IN REPLY REFER TO:
NCPC File No. Z.C. 02-30

AMENDMENT TO ZONING MAP OF THE DISTRICT OF COLUMBIATO ZONE PROPERTY FROM UNZONED TO W-0 OPEN SPACE FOR THE GEORGETOWN UNIVERSITY BOATHOUSE

AMENDMENT TO ZONING MAP OF THE DISTRICT OF COLUMBIA TO ZONE PROPERTY FROM UNZONED TO W-0 OPEN SPACE FOR THE GEORGETOWN UNIVERSITY BOATHOUSE

NEW NON-MOTORIZED BOATHOUSE

The photomontage finally provided by Georgetown University in December of 2002.

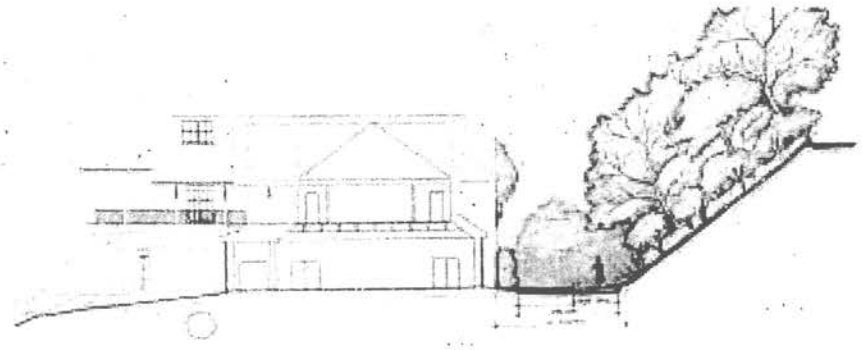
b) The proposed design was strenuously objected to by the C&O Canal NHP Presidential Advisory Commission along with dozens of other organizations. Mr. Parsons (NCR NPS) had previously and repeatedly claimed to have the Commissions approval. He further used that approval as proof that others did not share our concerns of damage to the C&O Canal NHP. I attended the meeting where he presented the proposed design that all members of the Commission as well as the Supervisor of the C&O Canal NHP Park. In addition to the Commission unanimously voting to raise concerns about the size and height of the structure, Mr. Ferris was heard to loudly comment: "It's too large John".

c) The size of the proposed structure has no legitimate rowing basis. Surely GU doesn't need a boathouse double the size of Thompsons for only 170 students. It's also more than triple the size of the average boathouse and seven times the size of it's nearest neighbor. This structure will not solve the "rowing crisis" caused by the Swedish embassy; it only exacerbates it by raising the red flag. Further, Georgetown has a very small number of "Eights" (16) at Thompsons. GU leaving will do little to solve the space problem.

Side view of the proposed GU Boathouse, 21 feet above the canal and 7 feet above Canal road

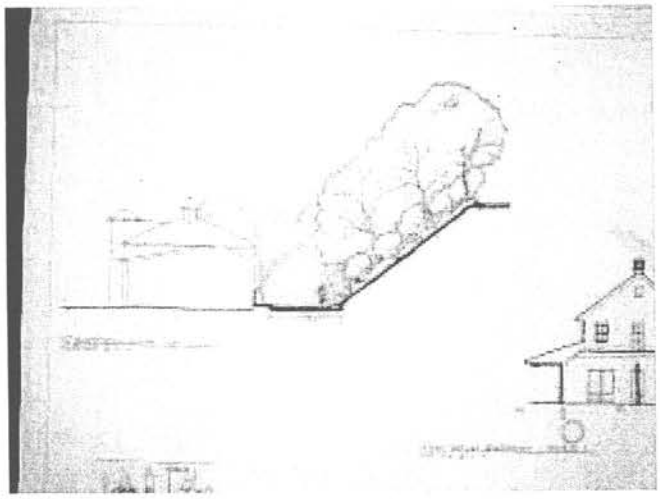
d) Significantly, the NPS, DC SHPO and the ACHP agreed during the Historic Review Process that the building would be 1/3 lower and 2/3rds smaller than proposed. NCPC was a signatory to this 106 process, which the proposed structure violates.

e) The building is so large that by the exchange agreement between NPS and GU, NCPC must approve its encroachment west into the C&O Canal NHP.
